Design Advice Request

FOLLOW-UP MEMO

Date: 8/15/2023
To: Portland Design Commission
From: Tanya Paglia, Design & Historic Review Team
503-865-6518 | Tanya.Paglia@portandoregon.gov
Re: EA 23-050424 DA – Con-way Block 292 East
Height Modification
Design Advice Request– August 17, 2023, Meeting

Freewell (Block 291 East)

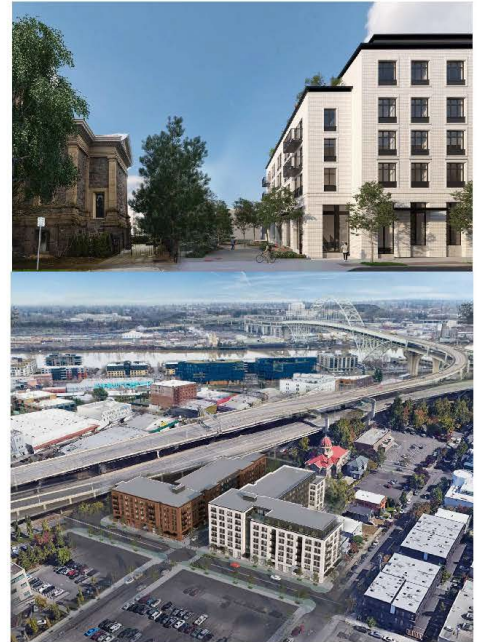
- Abuts Quimby Festival St & across from future park
- 2-story amenity pavilion steps down to Festival St & park with taller L-shaped building wrapping it
- Follow-up Review to design portion of Festival St & potential design changes when park is designed

MEETS HEIGHT LIMIT

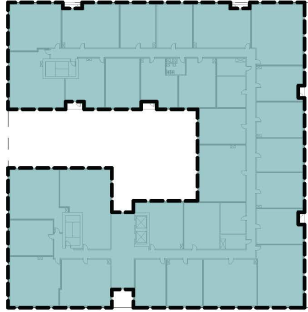
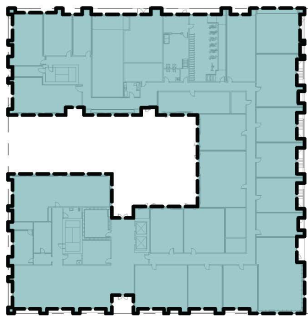
- The project could be redesigned as a more traditional 6-story building that meets the height limit with no setbacks towards the top of the building. The project team took roughly the same gross square footage that would be achievable in a sixth level and put it into two much smaller floorplates on levels 6 and 7 (note: the taller building would technically have more SF because they aren't counting the lofted areas of the 7th floor which would count towards FAR).

GROUND FLOOR	32,379 SF
LEVEL 2	32,379 SF
LEVEL 3	32,379 SF
LEVEL 4	32,379 SF
LEVEL 5	32,379 SF
LEVEL 6	32,379 SF
TOTAL	194,274 SF

PROPOSED DESIGN

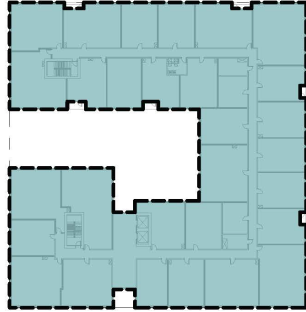
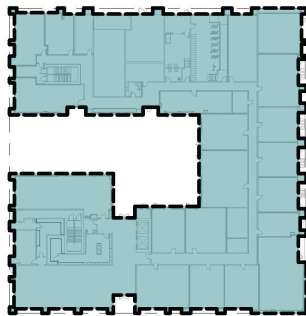
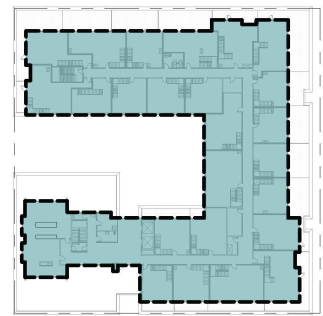
- The applicant provided the following breakdown of the requested 19' height modification:
 - 6' of the modification is from the top of eave to the mid-point of the gable
 - 13' of the modification is from the 67' max height to the top of the eave
 - Without the gable roof, the height modification would be in exactly the same range as Blocks 291E (13') and 262 (16')

GROUND FLOOR	30,347 SF
LEVEL 2	32,272 SF
LEVEL 3	32,272 SF
LEVEL 4	32,272 SF
LEVEL 5	32,272 SF
LEVEL 6	18,409 SF
LEVEL 7	12,447 SF
TOTAL	194,277 SF

MEETS HEIGHT LIMIT

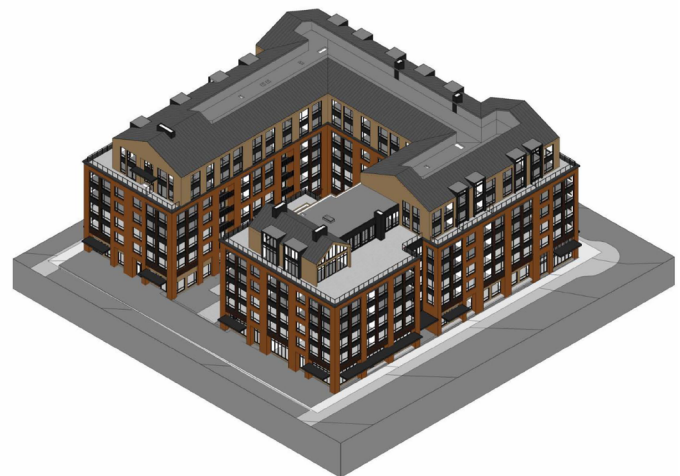
- The gabled roof form creates interest and variety but adds height. If the building were designed with a 2-level penthouse with a flat roof, the height Modification request would be less (for gabled roofs, height is measured to the mid-point of the gable).

- 6 STORY BUILDING
- 67' HEIGHT
- 195,000 SF FAR

- 7 STORY BUILDING
- 86' HEIGHT TO MID POINT OF GABLE
- 195,000 SF FAR
